Pacific Pines
Part 3A Application (MP 07_0026)
Preferred Project Report

Preferred Project Report

Prepared for: Petrac Pty Ltd
Project Manager: Rob van Iersel
Ref: 955654
Date: June 2008
© GeoLINK, 2008

Illustration 1.3 Derivation of Height Control

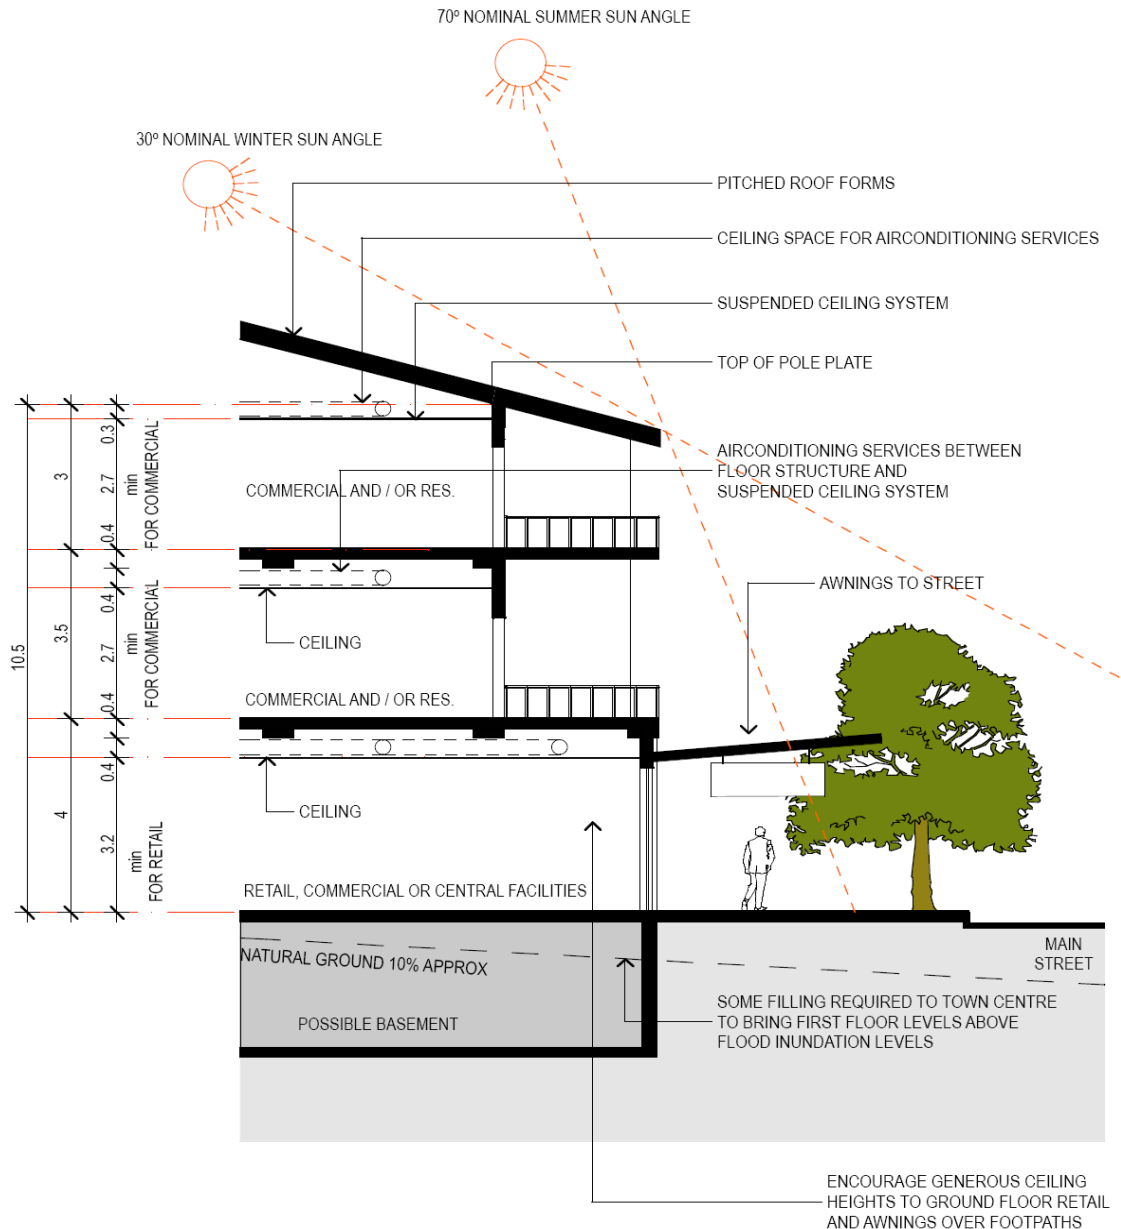
The bulk of this change represents a redefinition of the control. The original 15m control proposed in the EA documentation suggested that the measurement of 'height' be from natural ground level to the highest point of the building. This has now been amended to accord with the height control outlined within the Ballina LEP, which defines height as *'in relation to a building the topmost floor of which has a ceiling, means the distance measured vertically from any point on the ceiling of the topmost floor of the building to the ground level immediately below that point'*.

- the area proposed for three storeys has been reduced;
- the proposed height limit (i.e. metres above ground) has been redefined for the three storey control, to be consistent with the height definitions used in the Ballina Local Environmental Plan 1987; and
- the overall height limit has been reduced by 0.5m within the neighbourhood centre and 1.0m in the retirement community.

Illustration 1.4 Retirement Community Buildings Height

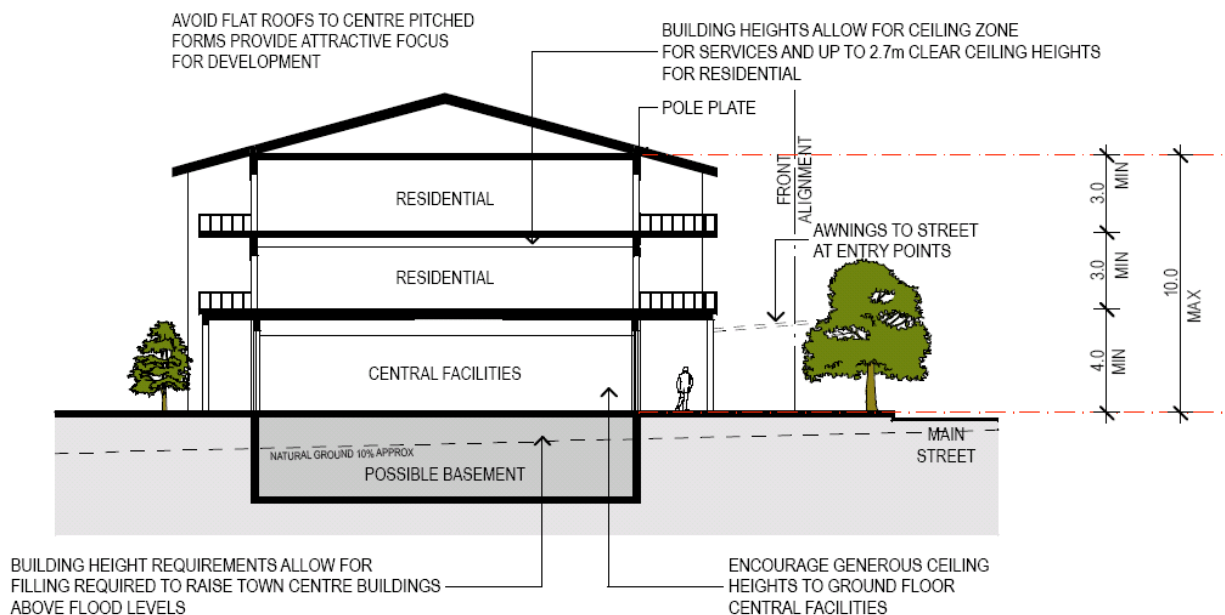
- the Pacific Pines neighbourhood centre needs to be subservient to the existing Lennox Village Centre, and three storeys will result in a centre that is bigger than Lennox Village;
- questions as to why three storeys needs to also include a 15m height limit; and
- impacts on views and the visual impact of three storeys.

The retirement building heights have been amended as a response to the submissions during exhibition. Again, the three storey height control has been redefined to accord with the Ballina Shire Council requirements and a reduction of 1.0m is being proposed for that control, as a result of further design and function analysis of the integrated retirement community.

Illustration 1.4 shows a cross-section of the structure measurements and the graduation of the total height.

Illustration 2.1 Lake Access Cross-Sections

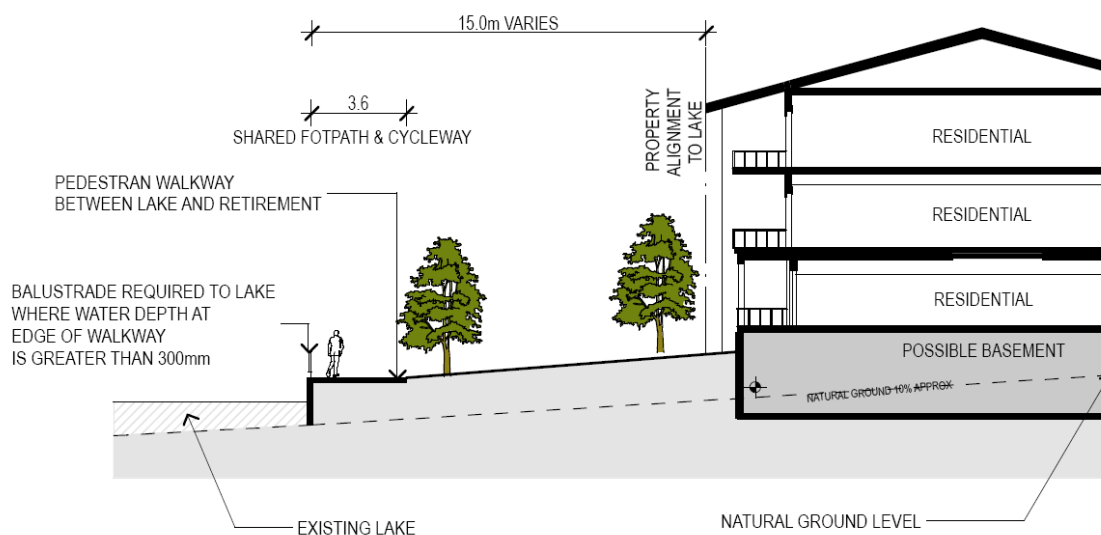
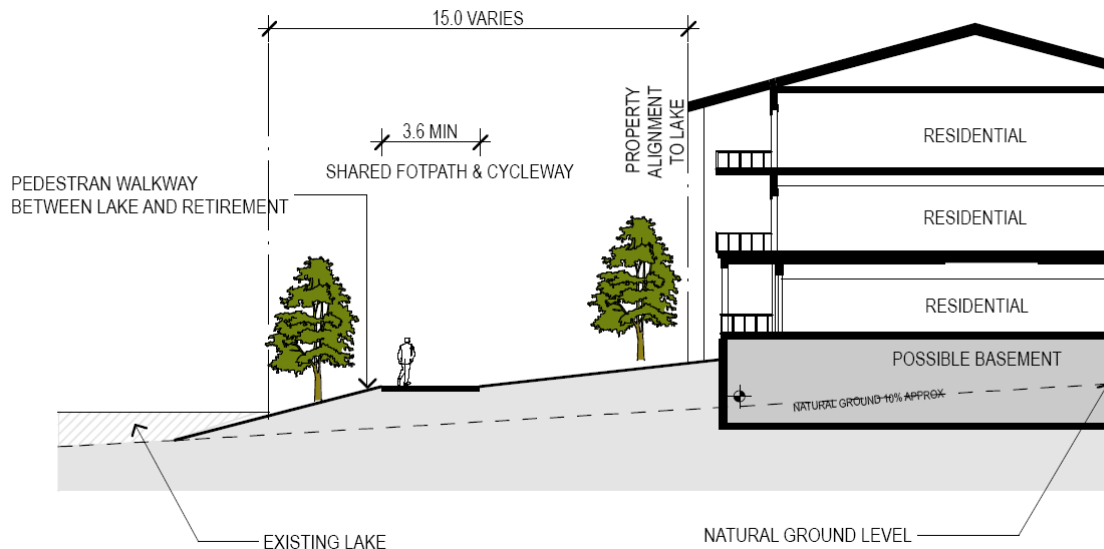
Clarification with respect to public access along the lake is provided in **Illustration 2.1**, which shows two typical cross sections. The indicative layout of buildings in this area is shown in **Illustration C3** of the Concept Plan drawing set. Please note that the Concept Plan design principles support a walkable and integrated layout, with the public access to the lake highlighted in **Illustration C6 Movement Network**.

As shown, three storey building elements are proposed as perimeter form building types. Perimeter form building types generally do not have narrow gaps between buildings that generate narrow shaded areas during winter. When gaps do occur between 3 storey building elements, they are wide and less prone to overshadowing impacts from adjoining buildings. Refer indicative building height sections.

Illustration 2.1 above and **Illustration C10** within the Concept Plan drawing set demonstrate the interface between buildings and the pond as well as the location of public pedestrian linkages.
